## Product Change Notification / JAON-18YDKI646

CCB 5014.002 Initial Notice: Qualification of a new die size (1.932x1.860mm) for Die #1 of selected Microsemi LE9641PQC, LE9651PQC, LE9641PQCT, and LE9651PQCT catalog part numbers (CPN) available in 48L VQFN (7x7x1.0mm) package assembled at MTAI assembly site.

**Qualification of a new die size (1.932x1.860mm) for Die #1 of selected Microsemi LE9641PQC, LE9651PQC, LE9641PQCT, and LE9651PQCT catalog part numbers (CPN) available in 48L VQFN (7x7x1.0mm) package assembled at MTAI assembly site.**

# Pre and post change comparison

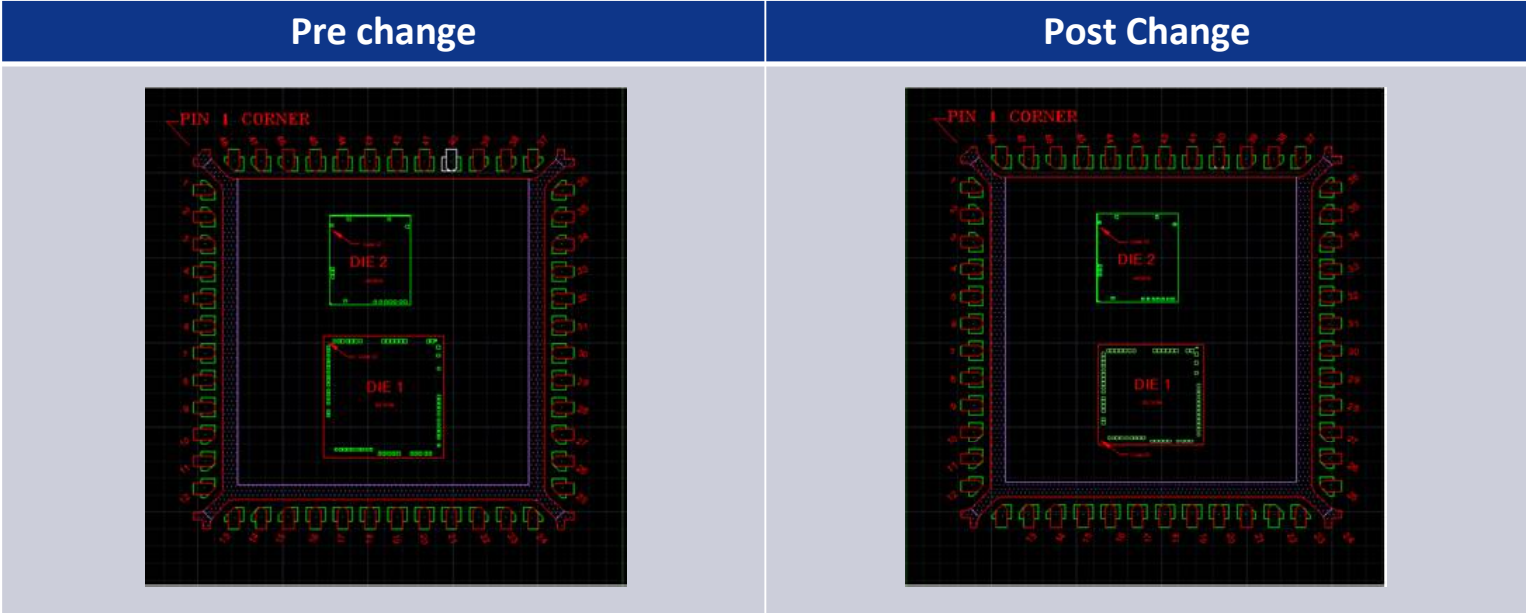
**Description of Change:**Qualification of a new die size (1.932x1.860mm) for Die #1 of selected Microsemi LE9641PQC, LE9651PQC, LE9641PQCT, and LE9651PQCT catalog part numbers (CPN) available in 48L VQFN (7x7x1.0mm) package assembled at MTAI assembly site.

Pre Change		Post Change	
Fabrication Location	Die # 1	Global Foundries, Singapore - Fab 7 (GF07)		Global Foundries, Singapore - Fab 7 (GF07)	
	Die # 2	Global Foundries, Singapore - Fab 2 (GF02)	Microchip Technology Colorado – Fab 5 (MCSO)	Global Foundries, Singapore - Fab 2 (GF02)	Microchip Technology Colorado – Fab 5 (MCSO)
Die Size	Die # 1	2.204 x 2.258 mm		1.932x1.860mm	
		Please see attached pre and post change comparison for Die # 1 Location			
	Die # 2	1.57 x 1.72 mm		1.57 x 1.72 mm	
Assembly Site		Microchip Technology Thailand (HQ) (MTAI)		Microchip Technology Thailand (HQ) (MTAI)	
Wire Material		CuPdAu		CuPdAu	
Die Attach Material		3280		3280	
Molding Compound Material		G700LTD		G700LTD	
Lead Frame Material		A194		A194
